Standards Committee

Meeting Agenda

Wednesday, July 5, 2023, at 9:00am

TITLE	Champion
<p>2nd time to Committee. Discussed in May.</p> <p>Twenty (20) proposed drawings and revisions to WVDOH Standard details Book – Volume 2. The sheets are listed below. A summary of each sheet’s revisions are included in the meeting packet; and proposed sheets have revised areas highlighted yellow.</p> <ul style="list-style-type: none"> a) <i>TE1-3A Roadside Sign Supports Steel Beam Type</i> b) <i>TE1-3B Roadside Sign Supports Steel Beam Type</i> c) <i>TE1-3C Roadside Sign Supports Steel Beam Type</i> d) <i>TE2-1A Bridge or Retaining Wall Sign Mounting, Type K 1 & 2 Supports</i> e) <i>TE2-1B Bridge or Retaining Wall Sign Mounting, Type K 1 & 2 Supports</i> f) <i>TE2-2 Bridge or Retaining Wall Sign Mounting, Type L Pipe Post Mount</i> g) <i>TE2-3 Barrier Wall Sign Support Bracket Type D</i> h) <i>TE3-1 Overhead Sign Support – Steel Two Tube Span (TTS)</i> i) <i>TE3-2 Overhead Sign Support – Steel One Tube Span (OTS)</i> j) <i>TE4-3A Overhead Sign Support – Steel Double Arm Cantilever</i> k) <i>TE4-3B Overhead Sign Support – Butterfly Cantilever</i> l) <i>TE4-4A Overhead Sign Support – Single Arm Ca

STANDARD SHEET TE1-3A

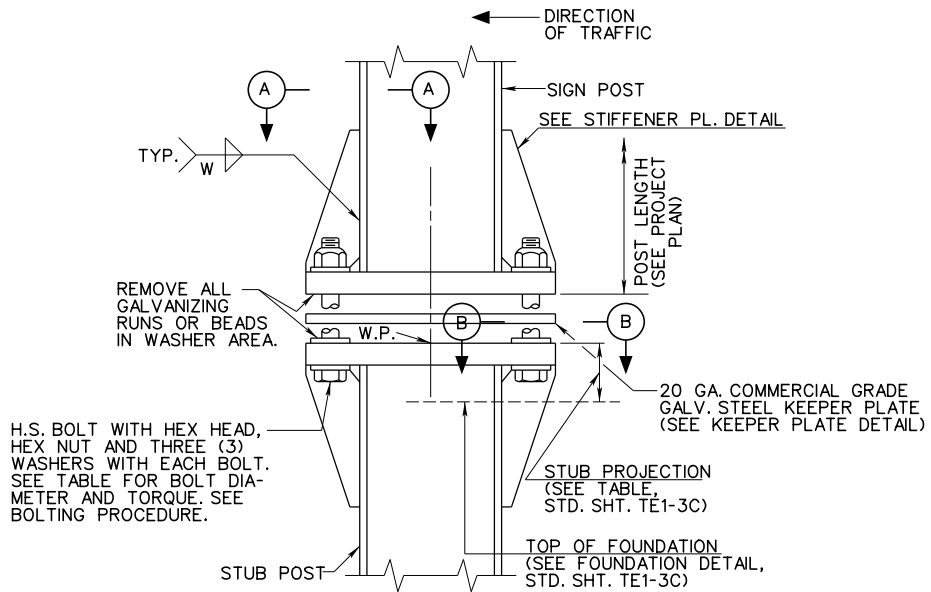
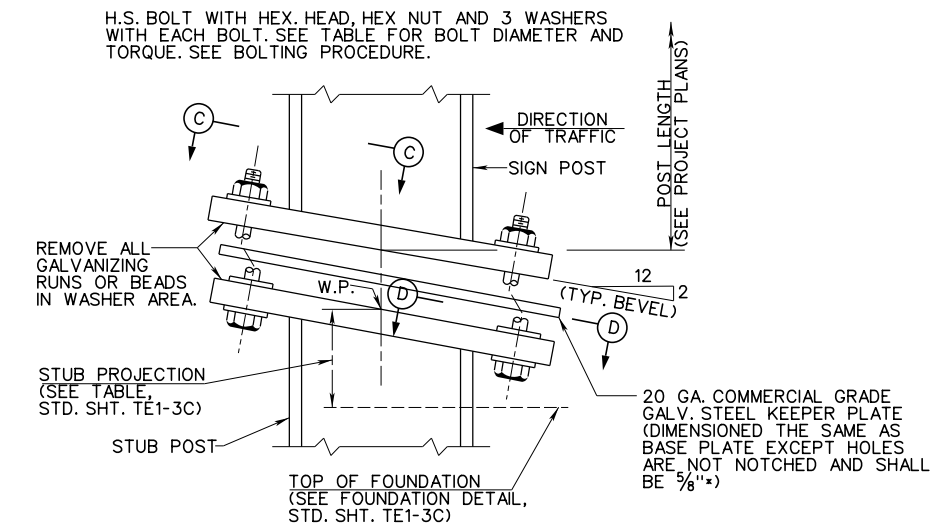
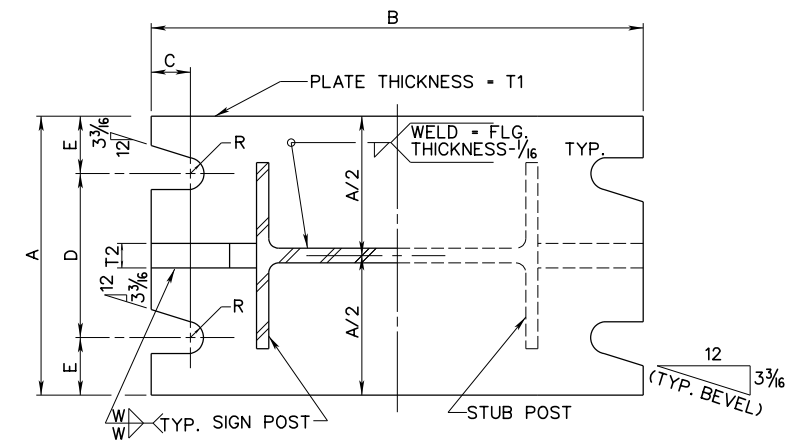
Sheet	Revision #	Date	Summary
TE1-3A	1	4/2022	Returned hinge plate dimensions to the previous standard. Revised T3 & D3 for S4 and W6 supports
TE1-3B	1	4/2022	Removed note allowing use of W10X22 behind guardrail or on a bench.
TE1-3C	1	4/2022	Returned to previous foundation sizes.
TE2-1A	1	11/11/2022	Increased the base plate to allow for more fasteners due to structural loads. Revised Note 1 to remove reference to three post option and to limit sign width to 6'. Revised Note 3 to clarify loads for fabricator to specify anchors. Added note to verify that the concrete structure mounting to will support these loads.
TE2-1B	1	11/11/2022	This option for three posts is not to be used. Loads are too great for typical bridge parapet.
TE2-2	1	11/11/2022	Increased the base plate to allow for more fasteners due to structural loads. Increased the number of required anchor bolts. This bracket is only allowed for Pipe Post Types 6 & 9. Note 4 was added to clarify loads for fabricator to specify anchors for retrofit option.

REVISED T3 & D3 FOR S4 & W6 SUPPORTS

STANDARD SHEET TE2-1A

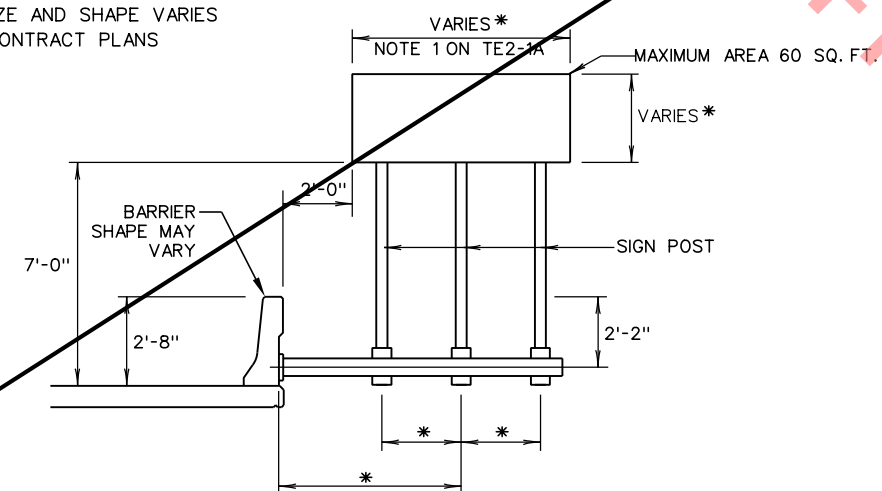
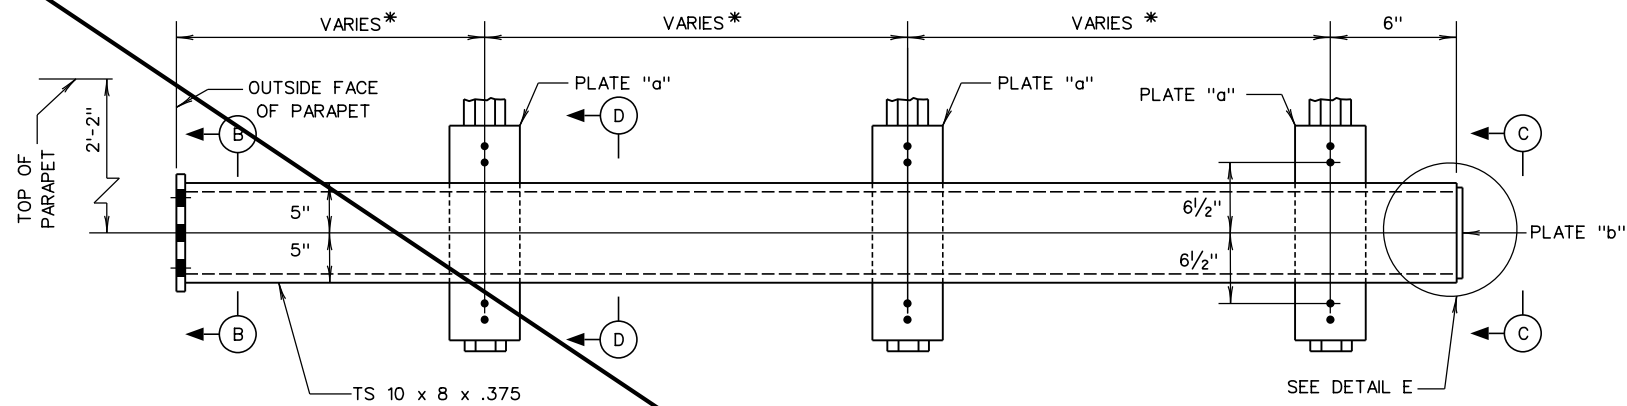
REVISOR NOTE 2 TO REMOVE REFERENCE TO 3-POST SUPPORT AND LIMIT SIGN WIDTH TO 6'.
REVISOR NOTE 3 TO CLARIFY LOADS.
REVISOR BASE PLATE DIMENSIONS TO INCREASE BOLT QUANTITY TO 8.

STANDARD SHEET TE2-1B

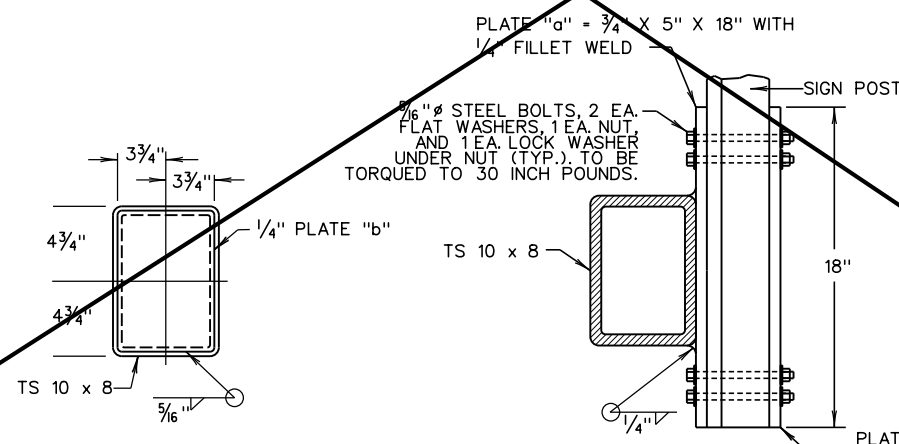
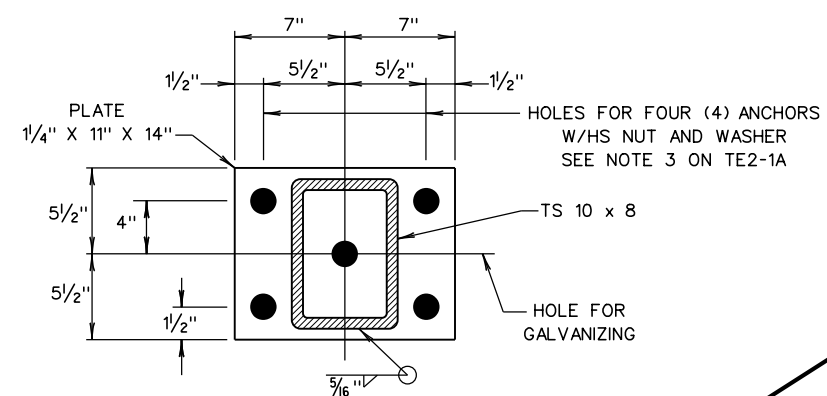
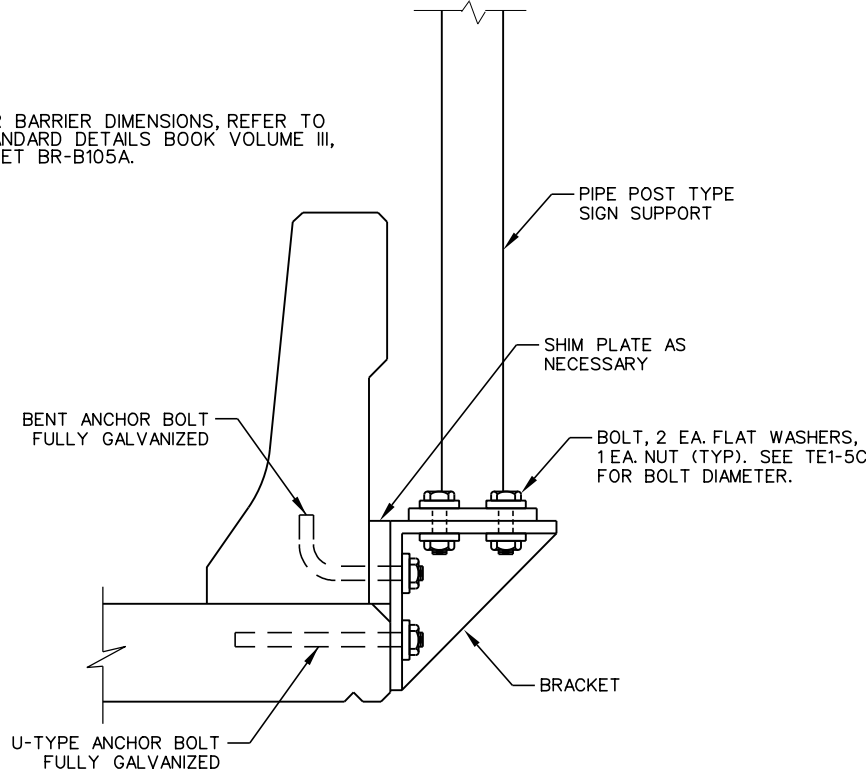
SHEET OBSOLETE. DO NOT USE.

**BRIDGE OR
RETAINING WALL
SIGN MOUNTING
TYPE L
PIPE POST MOUNT
STANDARD SHEET TE2-2**

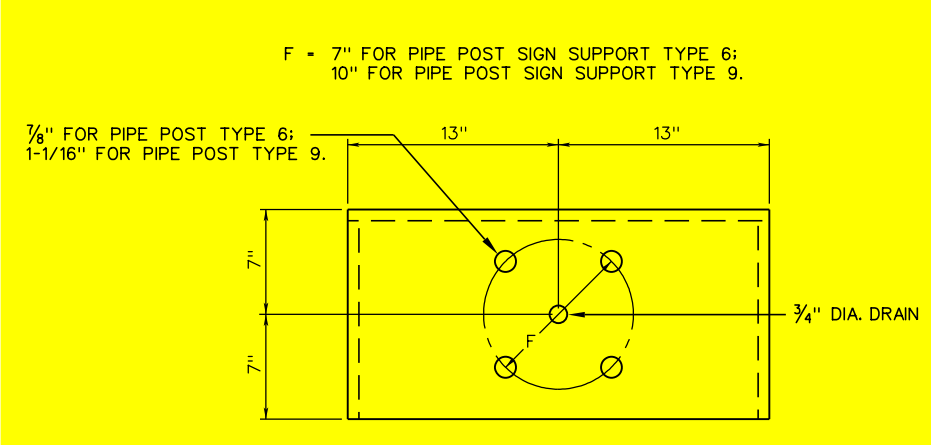
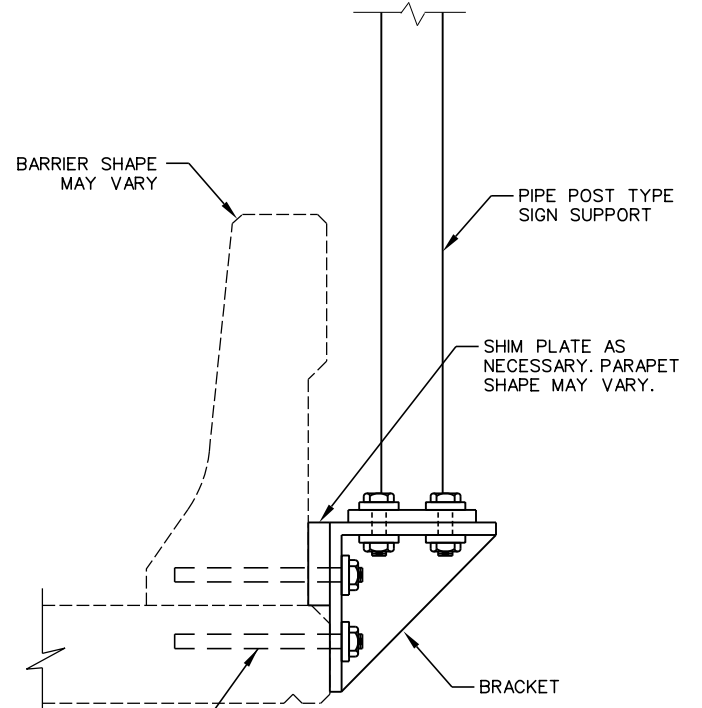
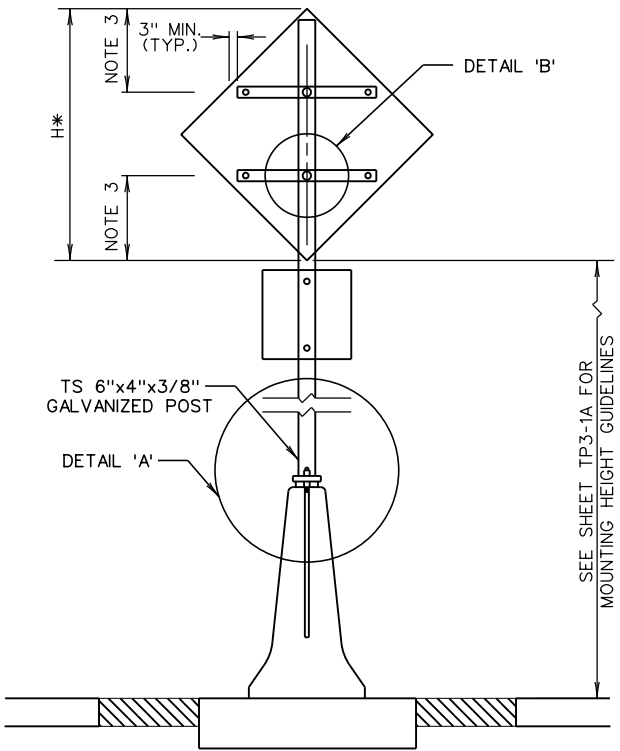
ADDED NOTE 4. REMOVED REFERENCE TO TYPES 7 & 8. INCREASED WIDTH OF BRACKET AND INCREASED NO. OF ANCHORS TO 8.

STANDARD SHEET TE2-3

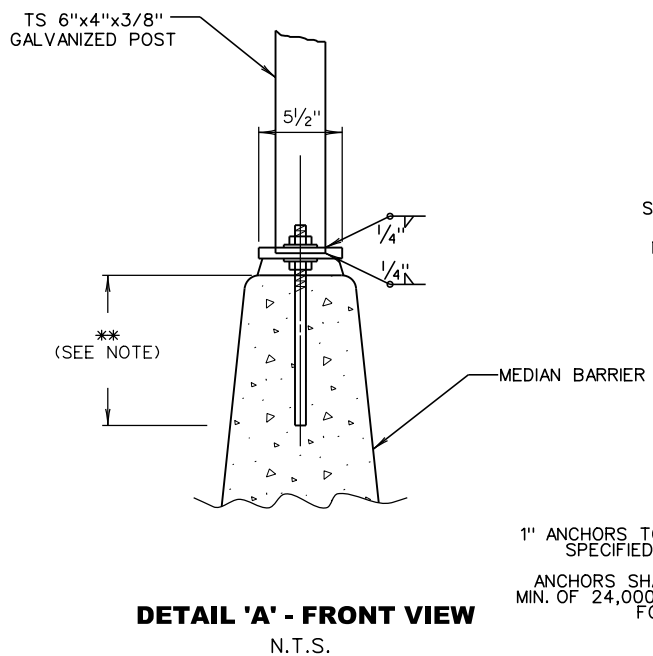
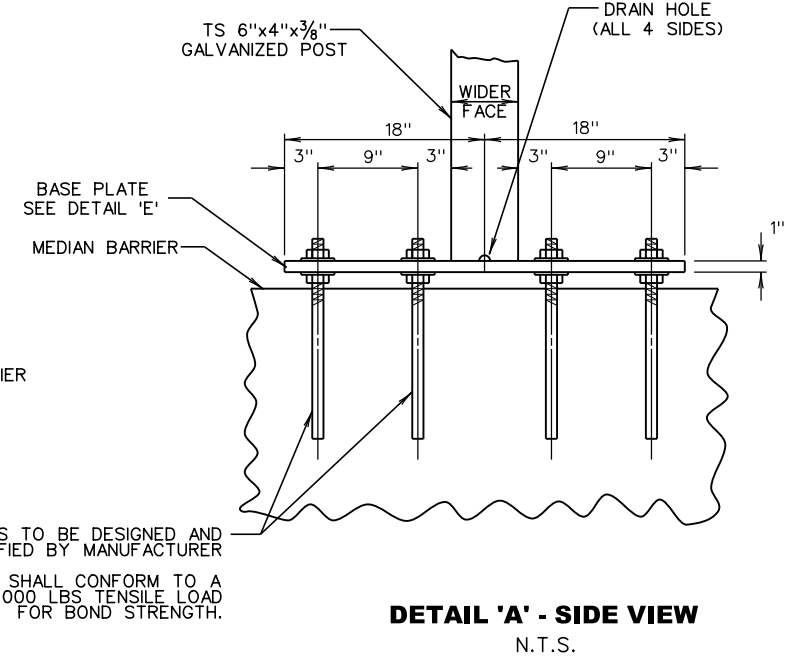
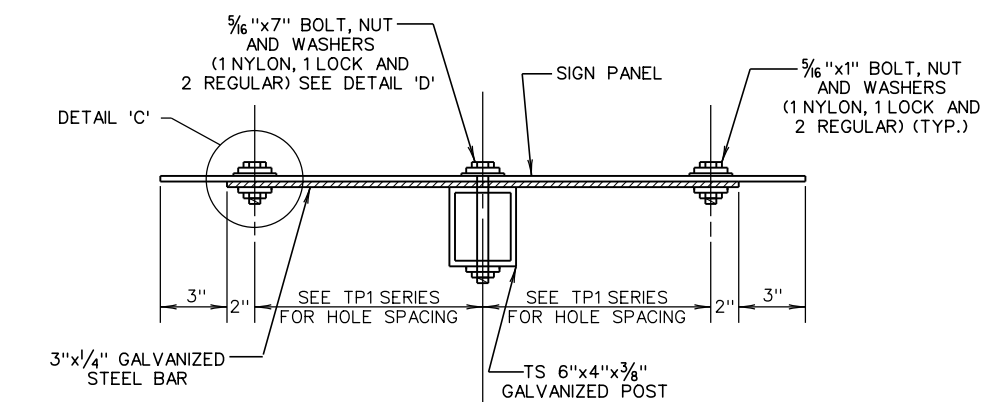
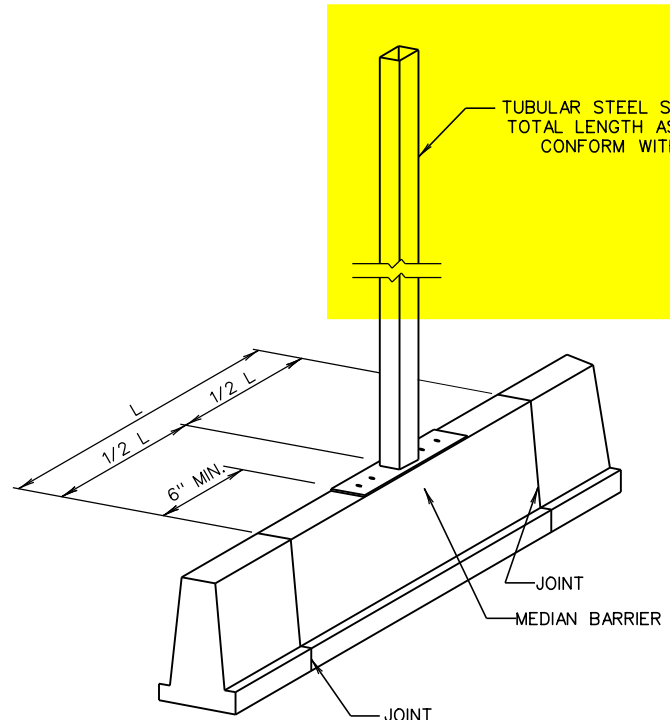
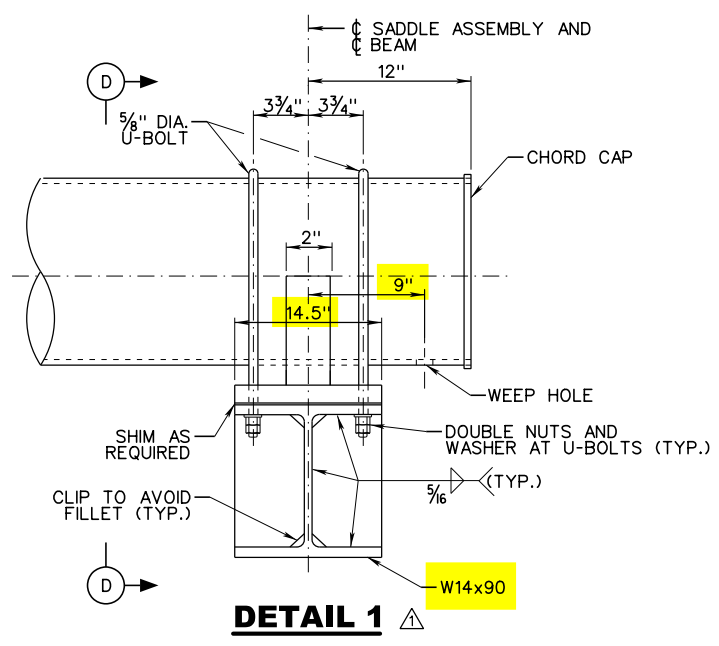
TE2-3	1	4/2022	Clarified the tubular steel post length to be based on TP3-1A.
TE3-1	1	2/22/2023	Increased the support bracket from W10X77 to W14X90 and revised associated dimensions. Added weld to flange portion of support bracket. Increased thickness of stiffener plate. Increased foundation diameter from 4'-6" to 5'-0" and number of vertical bars (See notes for TE3-2). Shifted Detail 4 and Coping Detail to make room for revision info.
TE3-2	1	6/2022	Added camber information to the sheet.
	2	2/22/2023	Increased the support bracket from W10X77 to W14X90. For TTS option, increased bolt circle (B) to 43" to meet the 1 1/2" clearance requirement between the nut and the post, which required the foundation diameter to increase. Decreased the S and F dimensions which previously were excessive. For the OTS option, increased bolt circle (B) to 26" to meet the 1 1/2" clearance requirement between the nut and the post. Increased the S and F dimensions. Increased the splice plate thickness (C) and added center hole diameter for base plate for both TTS and OTS types.
